Service Bulletin

SB 80-13

SUBJECT: Magneti, Marelli Digiplex Ignition Modules
VEHICLES: All 308 Fuel Injected Models (Up to C.N. 41753)

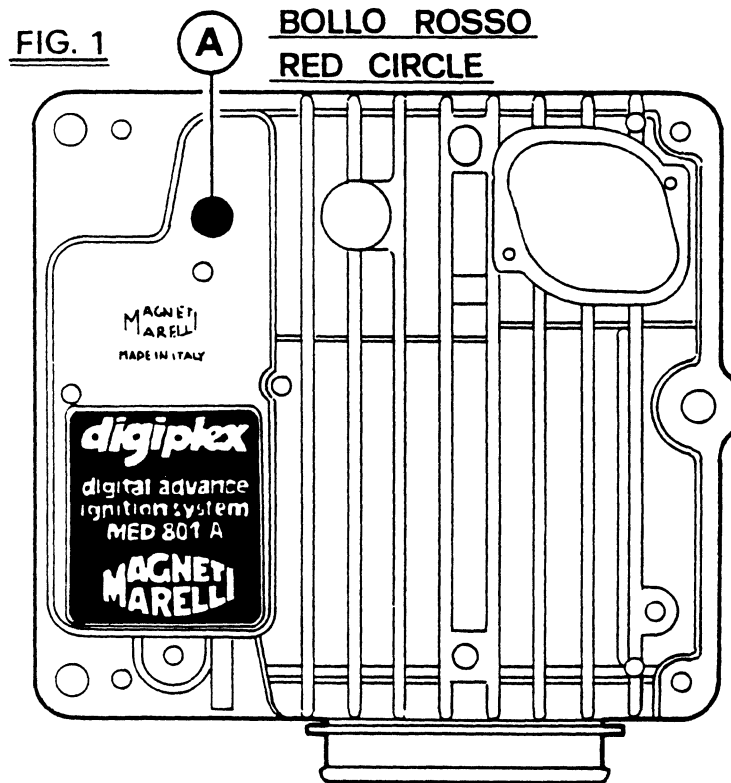
Magneti Marelli has added a slight modification to the Digiplex electronic ignition modules (part no. 115747), in order to avoid the possibility of occasional E.M.I. (electronic magnetic interferences). The updated Digiplexes keep the same part no. 115747, are identified by a red painted circle (A), Fig. 1, and have been introduced into production starting with chassis no. 41753.

It is advisable to extend the same modification to all 308 GTBi/GTSi and Mondial 8 with chassis numbers lower than 41753 when circumstances allow it.

RECOMMENDED: After replacing the Digiplexes with the updated ones, please ensure you paint a red dot on the upper face of the throttle shaft (In the engine compartment, near the intake manifold) in order to visually indicate that the updating has been made.

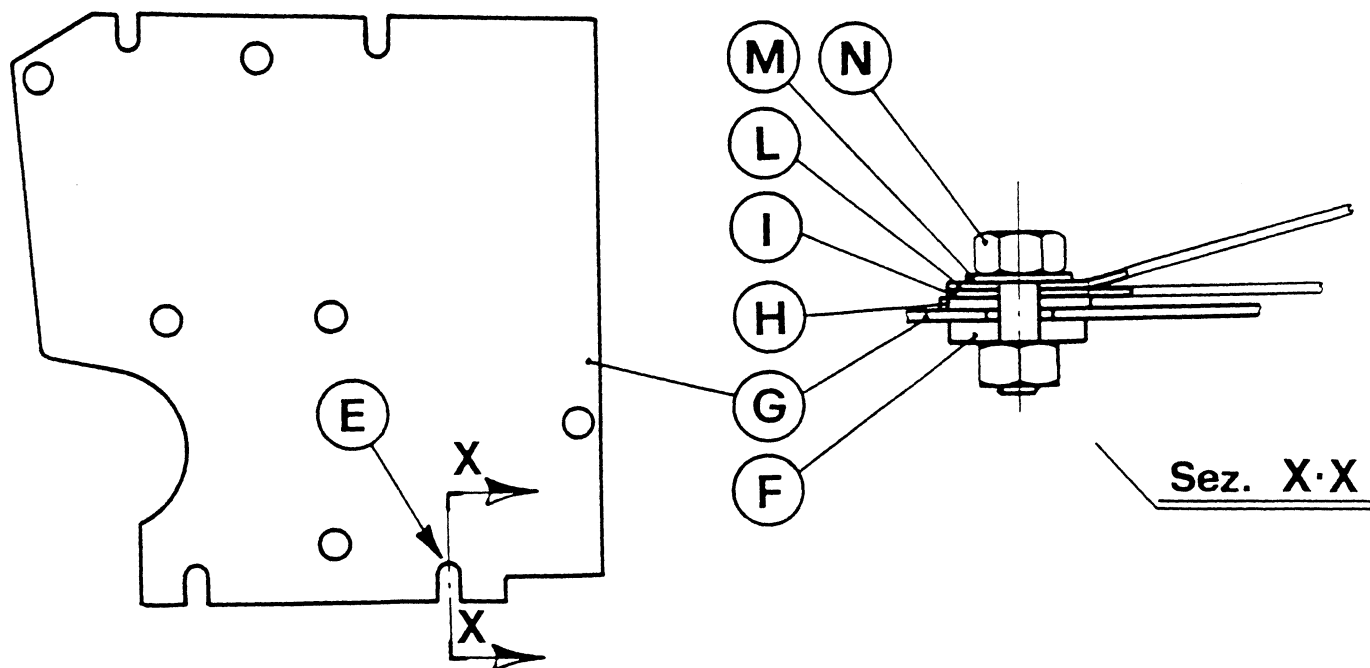
Whenever a new Digiplex is fitted to the car, you should always make sure the connections for the ground are correct by performing the following:

- Mondial 8 With a ohmmeter, check for 0Ω resistance between the Digiplex casings and any grounded element of either body or engine.
- 308 GTBi/GTSi Once fitted into the car, the Digiplexes are no longer accessible. In this case you should make sure that the ground cable terminals (I) and (L), Figures 2 and 3 are in the proper location and properly fitted, with a ohmmeter check that they are grounded

The ground terminals must be connected to the bolt of position (E), shown in Figure No. 2.

The correct sequence to fasten terminals (I) and (L) is shown by Figure No. 3 where, starting from the bottom, you can see the following pieces:

F — Threaded bracket, rigid with the body, corresponding to position (E), Fig. 2.

G — Detachable plate holding both Digiplex units (P.N. 115597).

H — Flat washer.

I-L — Ground cable terminals.

M — Spring washer.

N — Head of fastening bolt.
